LINE OF BUSINESS PORTABLE AUDIO

SERVICE NEWSLETTER

LINE OF BUSINESS AUDIO SYSTEMS

SERVICE NEWSLETTER

Portion of the Front board (copper side view)

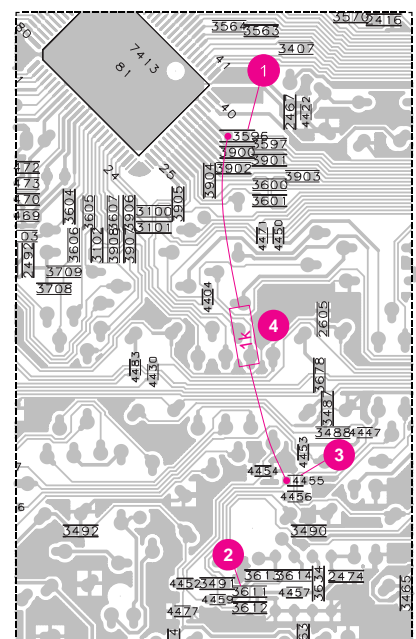
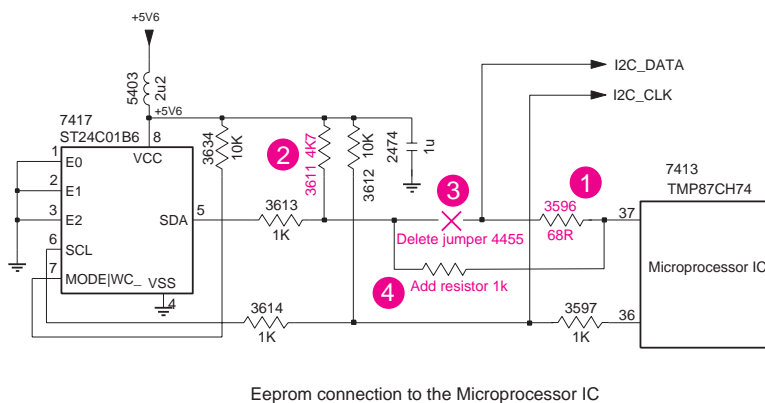
The set behaves strangely after switching it on via Standby button or mains supply re-connection. Strange behaviour includes:

- Loss of Tuner preset stations or tuning grid returns to 9kHz condition
- When changing source to Tuner the set stalls for a few seconds and may or may not switch to Tuner mode
- CD carousel rotates or the CD tray moves outwards
- Tape deck motors start to run or relay starts activation and the deck starts engaging and disengaging
- During this strange behaviour condition the set does not go into demo mode

CURE : The problem is caused by corrupted data being written into the EEPROM IC 7417 via the I2C_DATA line. The data corruption can be verified and cleared by performing an “EEPROM Format Test” in the Service Test Program.

The problem can be solved by the following hardware modification on the front board:

1. Ensure (change if necessary) that resistor 3596 is 68Ω (4822 117 12521)
2. Change resistor 3611 to 4.7kΩ (4822 051 20472)
3. Remove SMD jumper 4455
4. Add resistor 1kΩ (4822 050 11002) with insulated leads between pin 37 of microprocessor IC 7413 and junction of resistors 3611 and 3613 (left solder pad of jumper 4455)
5. Clear the corrupted data in the EEPROM as follows:
 - a) Enter the Service Test Program by holding the **PLAY ►** and **AUX** button depressed while switching on the mains supply
 - b) Perform an “EEPROM Format Test” by pressing the **SEARCH ◀◀** button to reset the EEPROM to default data
 - c) Exit the Service Test Program by disconnecting the mains supply

Portion of the Front board (copper side view)

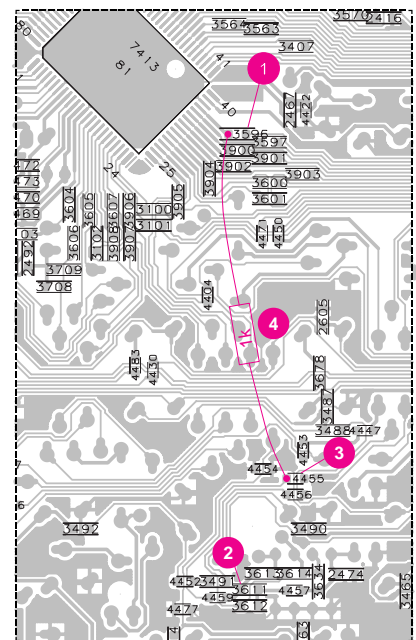
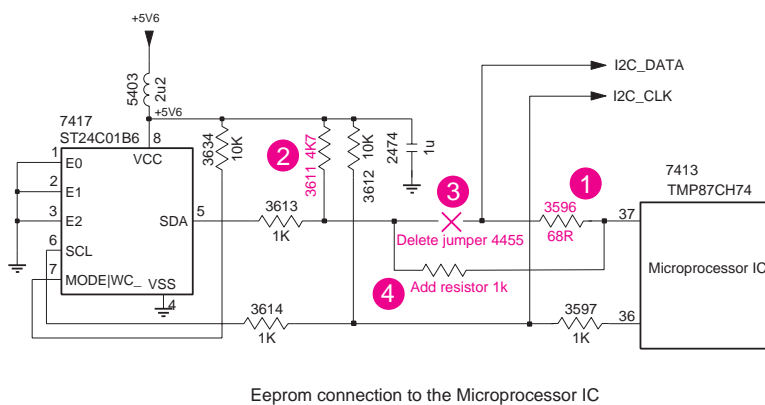
SYMPTOM : IRIS CODE M 1 7 0

- The set behaves strangely after switching it on via Standby button or mains supply re-connection. Strange behaviour includes:
- Loss of Tuner preset stations or tuning grid returns to 9kHz condition
 - When changing source to Tuner the set stalls for a few seconds and may or may not switch to Tuner mode
 - CD carousel rotates or the CD tray moves outwards
 - Tape deck motors start to run or relay starts activation and the deck starts engaging and disengaging
 - During this strange behaviour condition the set does not go into demo mode

CURE : The problem is caused by corrupted data being written into the EEPROM IC 7417 via the I2C_DATA line. The data corruption can be verified and cleared by performing an “EEPROM Format Test” in the Service Test Program.

The problem can be solved by the following hardware modification on the front board:

1. Ensure (change if necessary) that resistor 3596 is 68Ω (4822 117 12521)
2. Change resistor 3611 to 4.7kΩ (4822 051 20472)
3. Remove SMD jumper 4455
4. Add resistor 1kΩ (4822 050 11002) with insulated leads between pin 37 of microprocessor IC 7413 and junction of resistors 3611 and 3613 (left solder pad of jumper 4455)

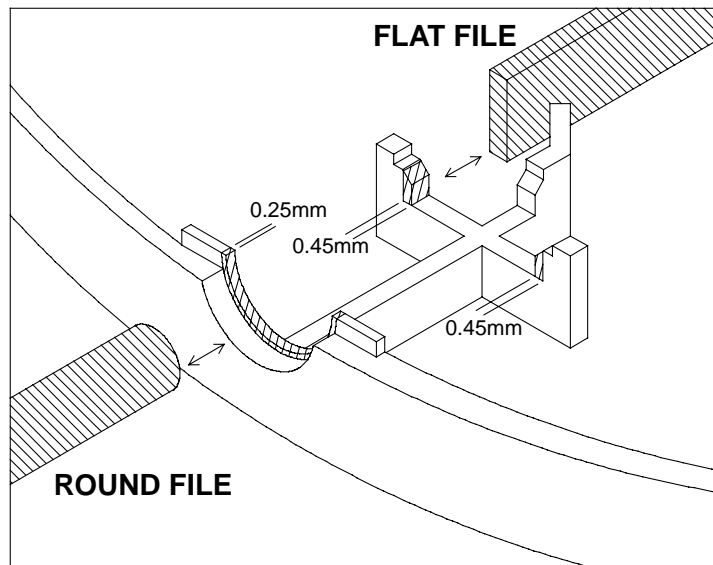
- SYMPTOM** : **IRIS CODE 6 1 1 X**
The Power ON/OFF switch 1496 or resistor 3594 is burst due to high transient current.
- CURE** : Additional to Service Newsletter PA99.02.11, on long term the layout of the Front board will be modified and following parts will be changed or added:
• Resistor 3456 changed to 15k Ω (4822 116 52244)
• Resistor 3457 changed to 5.6k Ω (4822 116 52289)
• Resistor 3516, 47 Ω (4822 116 52195) added
• Diode 7483 and 7484, 1N4148 (4822 130 30621) added
- REMARKS** : Modification will be implemented in production from week 9932 onwards.
This information will be followed by Service Information A99-573 (3140 785 22023).

fig.1 – location of flex-foils

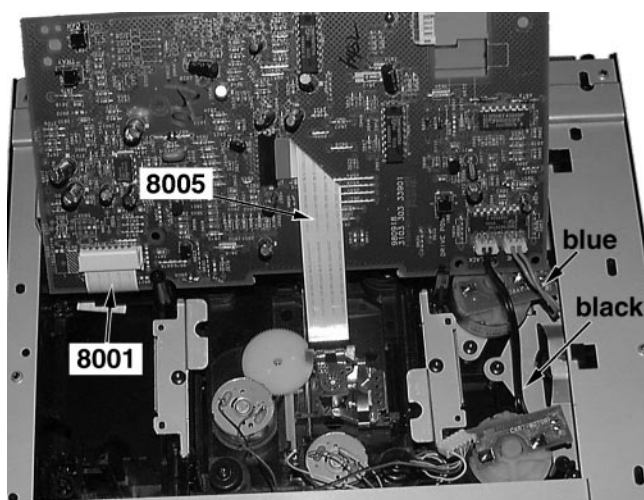
INFORMATION : Correction to the Service Manual, Partslist
The following flex-foils and flex-foil-connector were missing and have been added to the partlist of the 3CDC-99 Module (chapter 10).

pos.	code number	article description
1805	2422 025 09768	Flex-Foil-Connector 19P
8001	4822 320 12232	Flex-Foil 15P 480mm
8001	4822 320 12658	Flex-Foil 19P 480mm
8001	4822 320 12659	Flex-Foil 23P 480mm
8001	4822 320 12729	Flex-Foil 23P 400mm
8005	3103 308 91820	Flex-Foil 15P 95mm

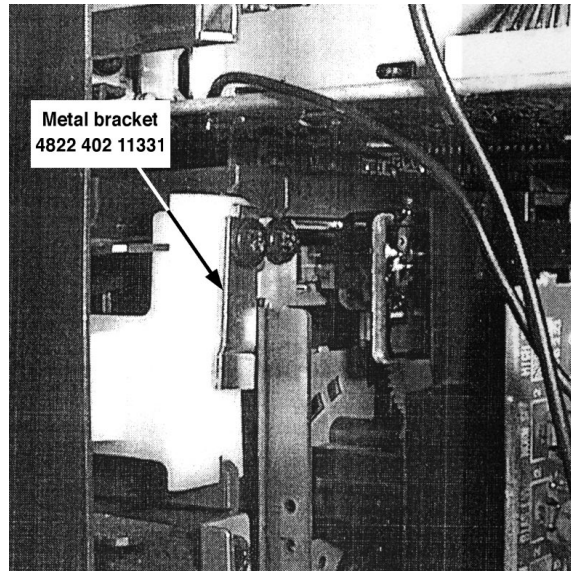
CURE : In addition to Newsletter issue AS98.09.03, the improved brackets (left & right) can be recognized by the modification shown below:

Sets with old brackets can be adapted by either

- i) adding a metal bracket (4822 402 11331) to press onto the back of the bracket left or right as shown below, or

- ii) replacing the old bracket by the modified one.

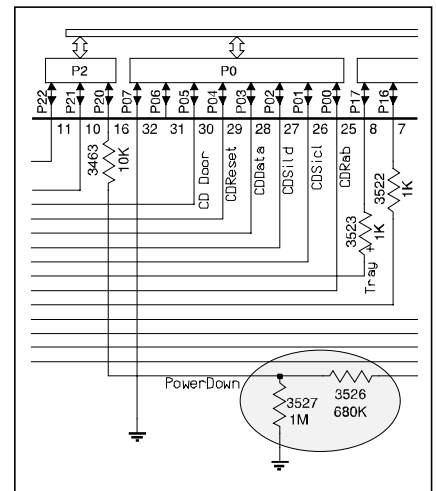
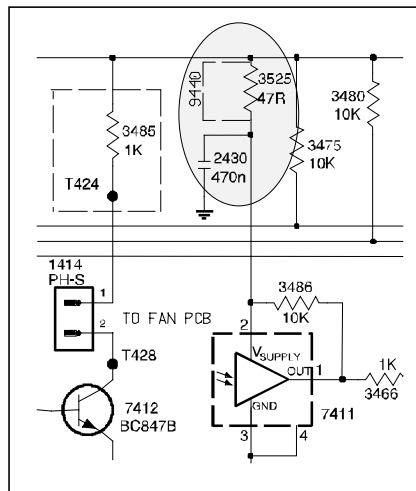
SYMPTOM : **IRIS CODE C 5 3 2**
 Sound is muted or distorted at start-up when playing a CD containing only two tracks.

CURE : The problem can be solved by adding a resistor of 100kΩ (4822 116 52234) across C445 on the CD board.

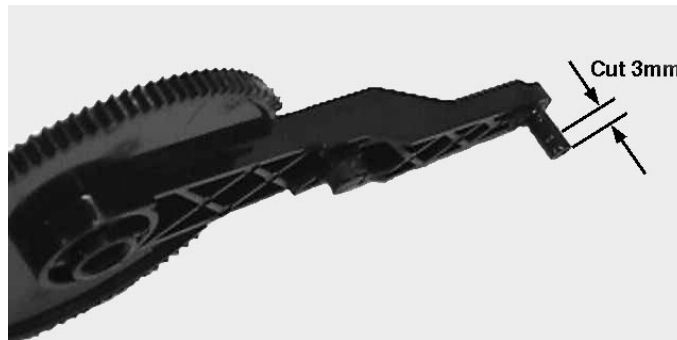
From production wk9835 onwards, the Tray and Crank have been modified. The groove on the tray is now deeper and likewise the pin on the Crank is 3mm longer.

Due to this change the new Crank does not fit into the old Tray anymore. But it is still possible to use the old Crank on the new Tray.

The new Tray can be recognized by its 10mm deep groove.

Because of limited stock of old Cranks, new Cranks have to be reworked for sets with an old Tray. This is done by cutting the pin by 3mm with a sharp NT-cutter (give it a clean cut & do not deform its circular cross-section) as shown below.

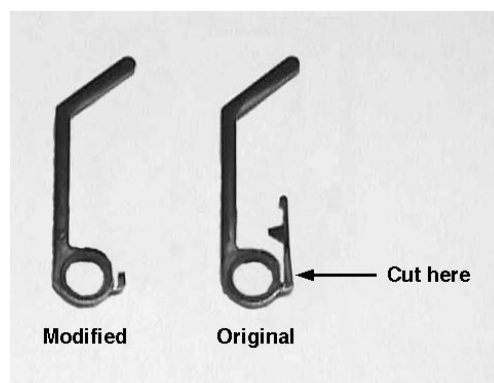
INFORMATION : **Replacement of CDM12.1 for 7-Disc Changer**
Production of CDM12.1 will stop. For service purpose CDM12.1 (4822 691 30278) will be replaced by service kit VAM1201 (4822 310 11263) when stock depletes.

For the above mentioned sets with 7-Disc Changer the new VAM1201 does not fit.

As an alternative, the CDM12.1 can be replaced by CDM12.1/T (4822 691 30343) without any further modifications.
